Docket Item #4 & #5
BAR CASE # 2017-00057 &
2017-00080

BAR Meeting
April 19, 2017

ISSUE: Permit to Demolish and Certificate of Appropriateness for Addition, Alterations and Waiver of Rooftop HVAC Screening Requirement

LOCATION: 907 King Street

Figure 1. View of existing conditions (left) and revised design (right) from North Alfred Street.

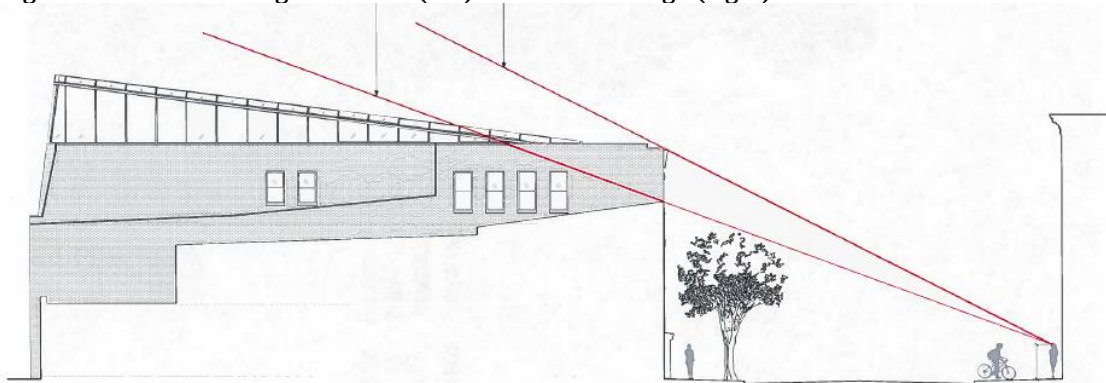
Staff is extremely supportive of the revisions since the previous BAR review and finds that many of the BAR's comments and concerns have been satisfied. The rear elevation has been subdued with respect to fenestration detailing and window frame system color and, while still simple and contemporary, no longer presents a jarring contrast to the historic building and its historic context (Figures 4&5). The revised third floor glass window wall on the rear now has the form of a traditional batten-seam mansard roof, which is the form that was also used very successfully on the addition to the historic red brick Victorian townhouse whose roof is, unfortunately, just out of view to the right in Figure 1.

Figure 2. PREVIOUS DESIGN Potential sight-lines from King Street and original skylight design showing west elevation.

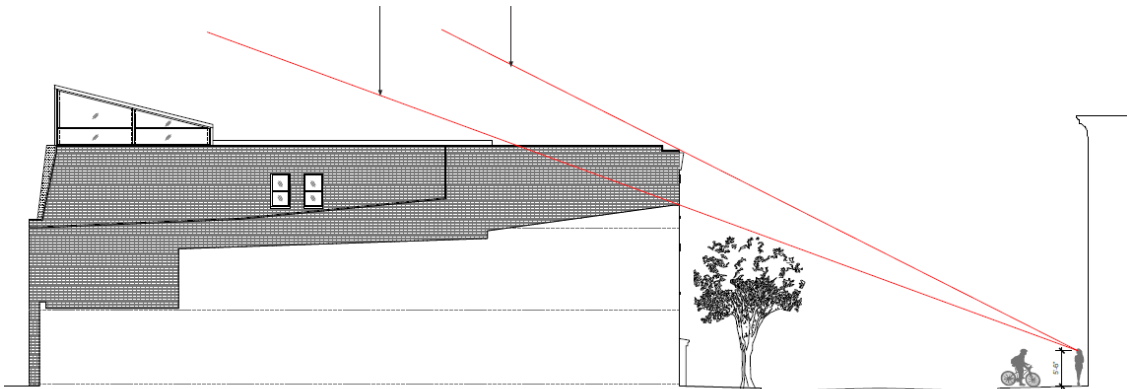
The overall size and design of the skylight above the stairway has now been significantly reduced to ensure that it is not visible from any perspective from King Street and to better integrate with the building as a whole (Figures 2, 3, 4 and 5). Additionally, the applicant addressed the BAR's comments regarding the front elevation by creating a more balanced and cohesive storefront area.

Figure 1: Potential sight-lines from King Street, looking north.
Courtesy of Studio 27 Architecture.

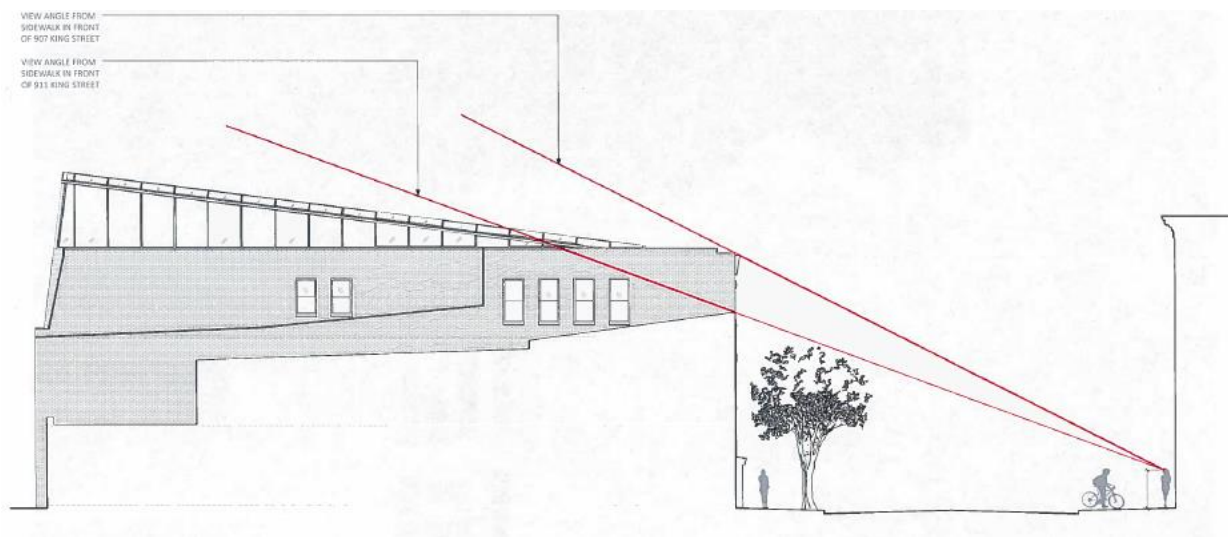
Although located on the roof and the rear of the building, the rooftop stairwell skylight system and the third-story window wall on the north elevation will be partially visible from King Street and clearly visible from North Alfred Street respectively [Figures 1-3]; therefore, compatibility with the extant building as well as with the historic urban context is a primary concern. The greenhouse-like stairwell element and the curtain wall appear to have been perched atop a historic, masonry building rather than to grow naturally from it, and details which might tie the two volumes (the old with the new) together are lacking. There is no precedent in Old Town for such large expanses of steel and glass on a historic structure. Although the slope of the curtain wall system generally mimics the present Mansard roof, that element is a late 20th-century addition that has little design relationship with the 19th-century core atop which it sits. While the metal-seam roof punctuated by a Post-Modern style, triangular, multi-light gable window has nothing in common with the rest of the building's fabric, and is slightly high-style for an alley elevation, it is at least benign and does not shout for attention. The side walls of that 1983 third-story addition are composed of bricks which successfully blend with the historic fabric and the roof is clad with grey colored standing seam metal that also blends with its surroundings.

Furthermore, BAR staff is very concerned that this glass skin will emit significant light at night, with the skylight over the stair calling for attention from King Street and the north elevation becoming a beacon on North Alfred Street. BAR staff recommends that the applicant provide a night rendering of the project demonstrating how this light will be mitigated so that the project blends with its surroundings at night.

Figure 5, left: Conceptual rendering of north (rear) elevation. Note the third-floor curtain wall has three lights. Figure 6, right: North (rear) elevation. Note the third-floor curtain wall has seven lights. Courtesy of Studio 27 Architecture

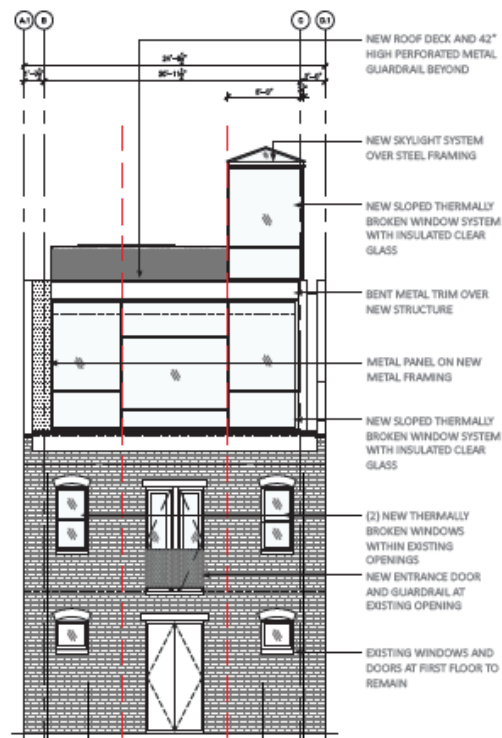
The existing Mansard roof with its centralized, triangular gable window on the third floor of the north elevation will be demolished and replaced by a new sloped window wall with metal framing which will be surrounded by a bent metal trim and a metal panel on the east side. While the conceptual rendering shows only three vertical lights, the elevation appears to depict joints which break the glazing wall into seven irregularly-sized lights. [Figures 5 and 6] The third-story curtain wall will be clearly visible from North Alfred Street.

On the second floor of the north elevation, the applicant proposes replacing the existing double-doors and transoms with two full-height, single-lite exterior doors, as well as replacing the existing guardrail (which has minimal balusters) with one in a basket-weave design. The applicant also proposes replacing the two existing windows with new windows; in the elevations, they are drawn as one-over-one (1/1) lights, but the standard window detail provided shows a two-over-two (2/2) light window. [Figure 7] Staff recommends that the applicant retain the one-over-one (1/1) light configuration. The first-floor fenestration and entrance will remain.
